Memorandum to the City of Markham Committee of Adjustment

File: A/054/21
Address: 51 Summerfeldt Crescent, Markham
Applicant: Shamez Mohamed
Agent: Shamez Mohamed
Hearing Date: Wednesday June 09, 2021

LOT 162
REGISTERED PLAN M-1441
IN THE
TOWN of MARKHAM
51 SUMMERFELDT CRES.
SCALE: AS SHOWN
PAGE: P01
DRAWN BY: ADD

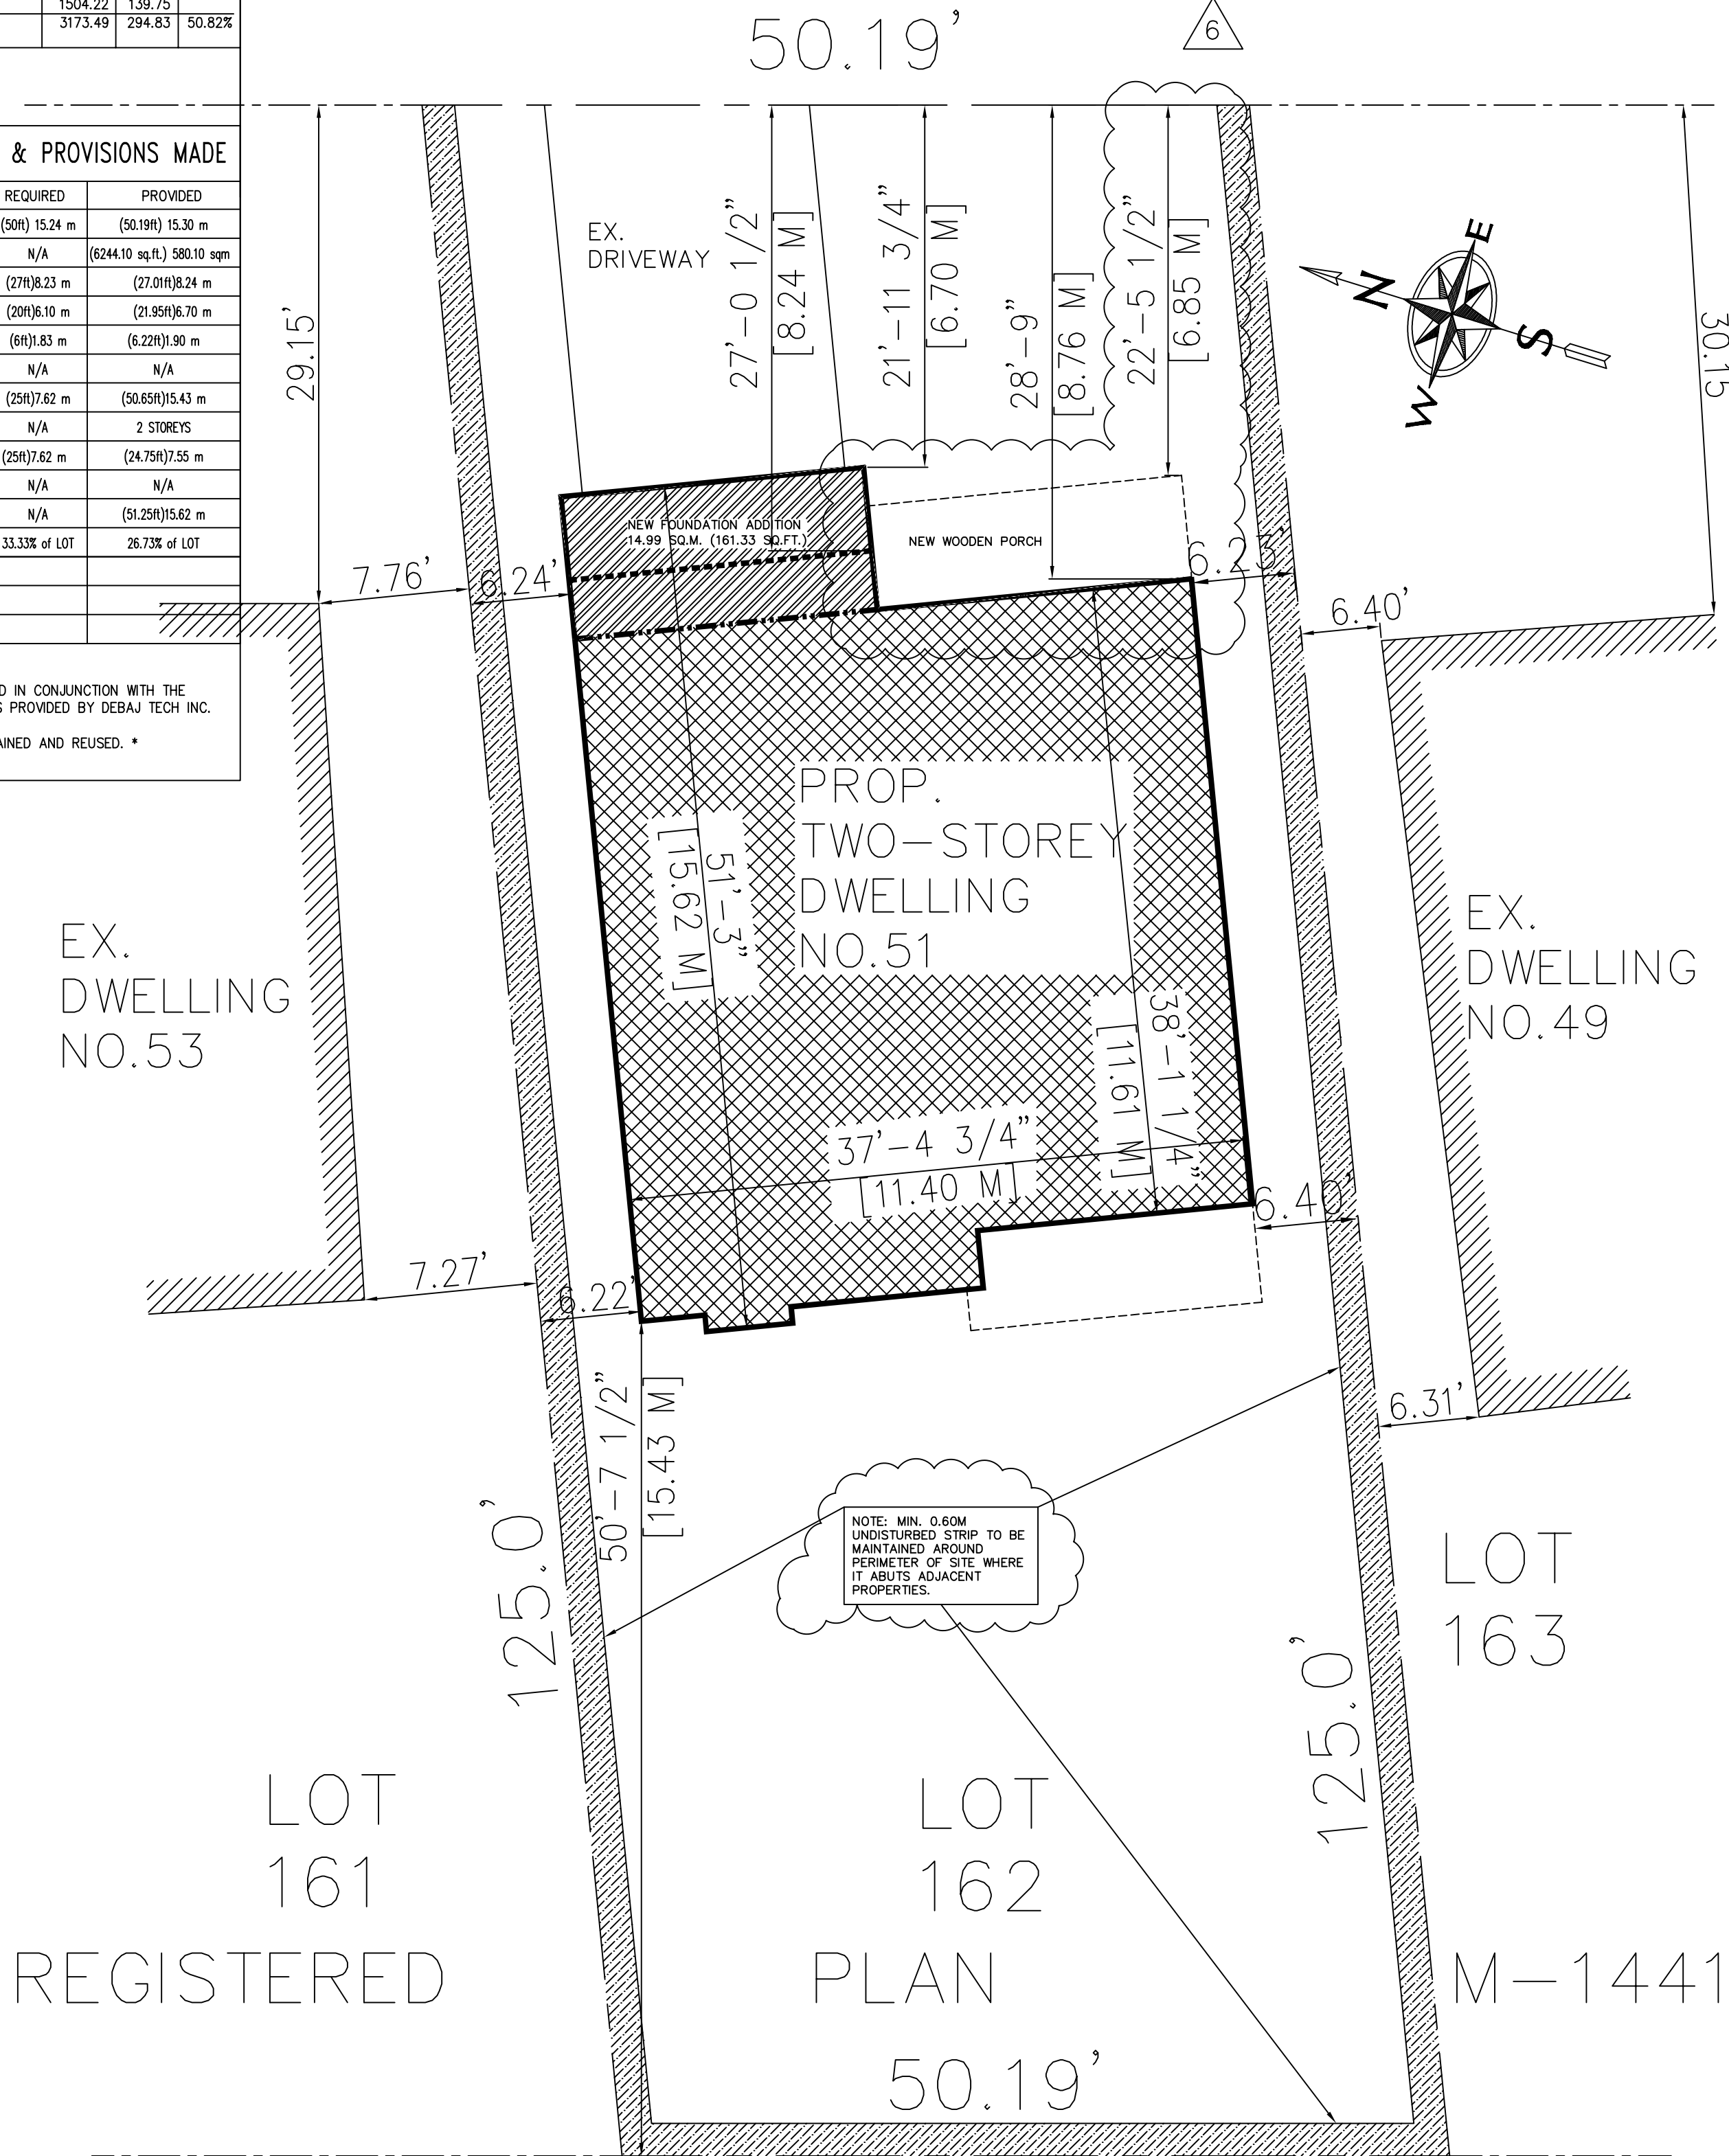
The applicant is requesting a maximum front covered porch projection of 4 ft 7 in (1.39 m), whereas the By-law only permits uncovered platforms to project into the required front yard to a maximum of 5 ft (1.52 m). This is noteworthy, as the existing porch would comply with the By-law if it were uncovered.

The applicant is not applying for variances for lot coverage or height. Furthermore, the existing covered porch is unenclosed and does not extend beyond the existing garage projection. Given the modest projection, Staff are of the opinion that the variance request is minor in nature and will have no adverse impacts to neighbouring lots.

1. That the front porch remain unenclosed;
2. The variance applies only to the proposed development as long as it remains;
3. That the variance applies only to the subject development, in substantial conformity with the plan(s) attached as Appendix “B” to this Staff Report and stamped by the City of Markham on June 03, 2021, and that the Secretary-Treasurer receive written confirmation from the Director of Planning and Urban Design or designate that this condition has been fulfilled to his or her satisfaction;

1 EAST ELEVATION
A04 SCALE: 1/4" = 1'-0"

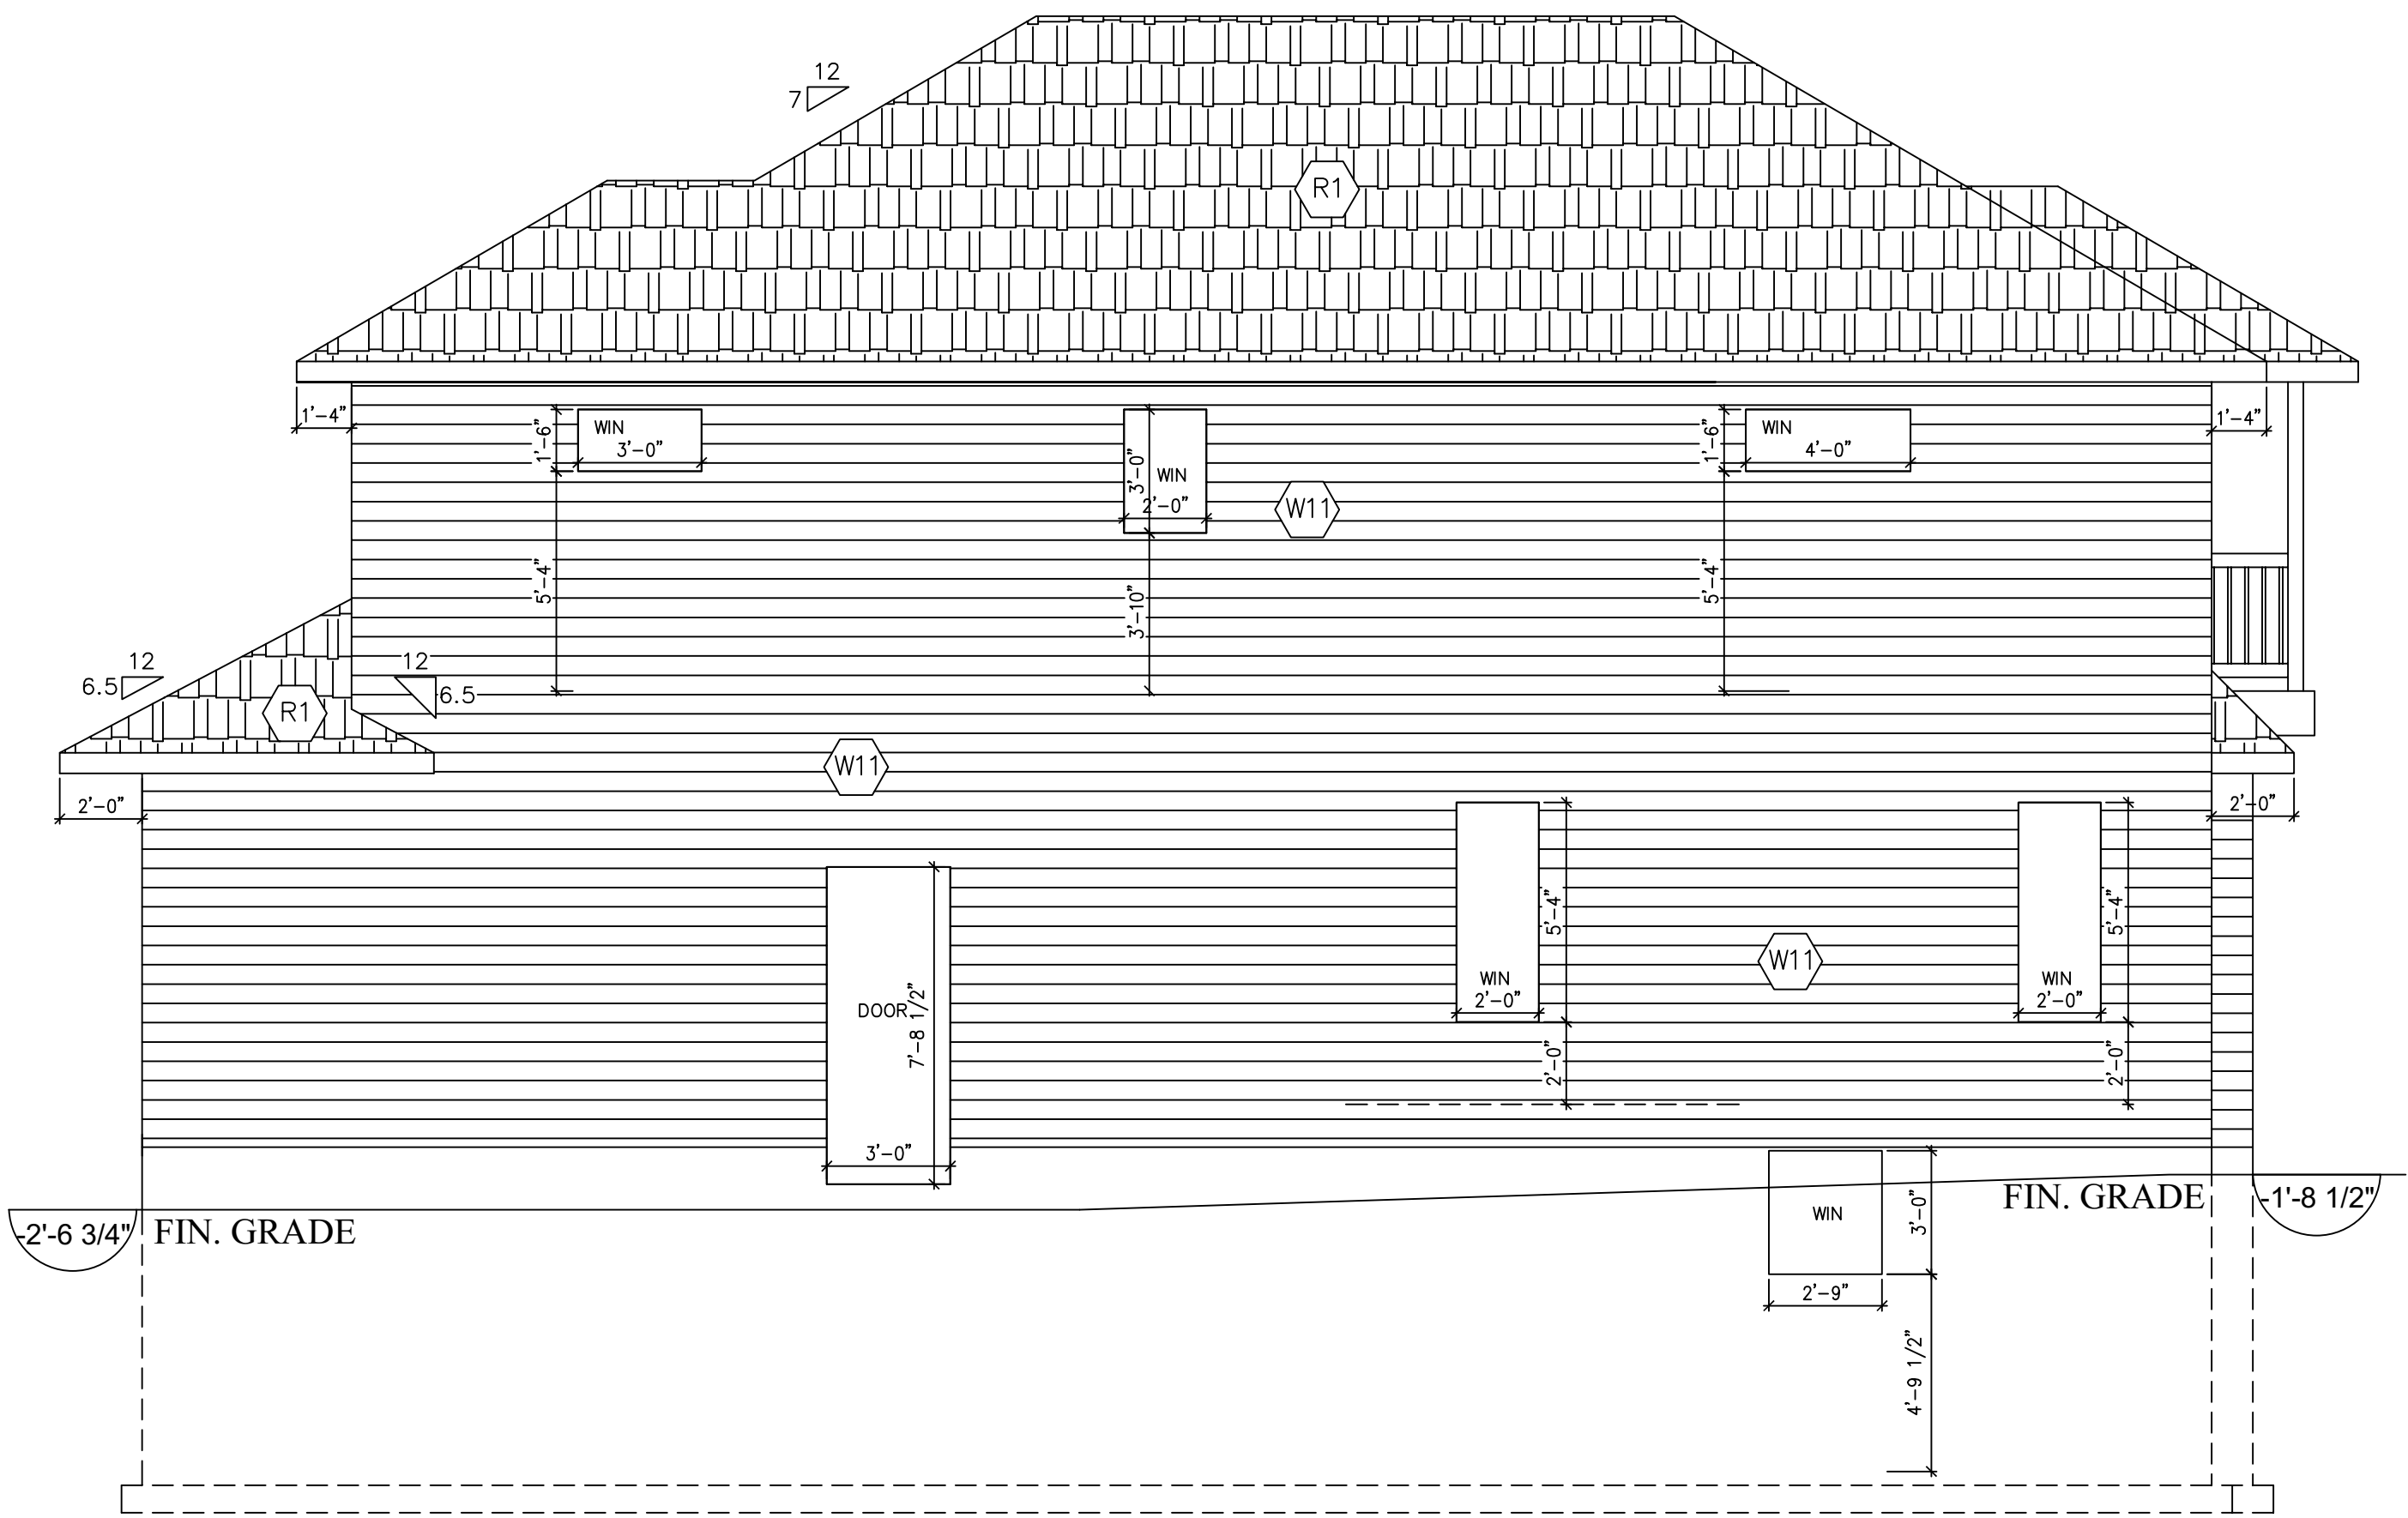
There is an existing, newly constructed, 294.83 m² (3,173.52 ft²) detached dwelling on the property. The Building Standards Department issued a building permit for the proposed dwelling in November 2018. During construction, the Applicant added a roof over the front porch, contrary to the approved permit plans and Zoning By-law standards. The existing unenclosed covered porch is the subject of this Minor Variance application (see Appendix B – Architectural Plans).
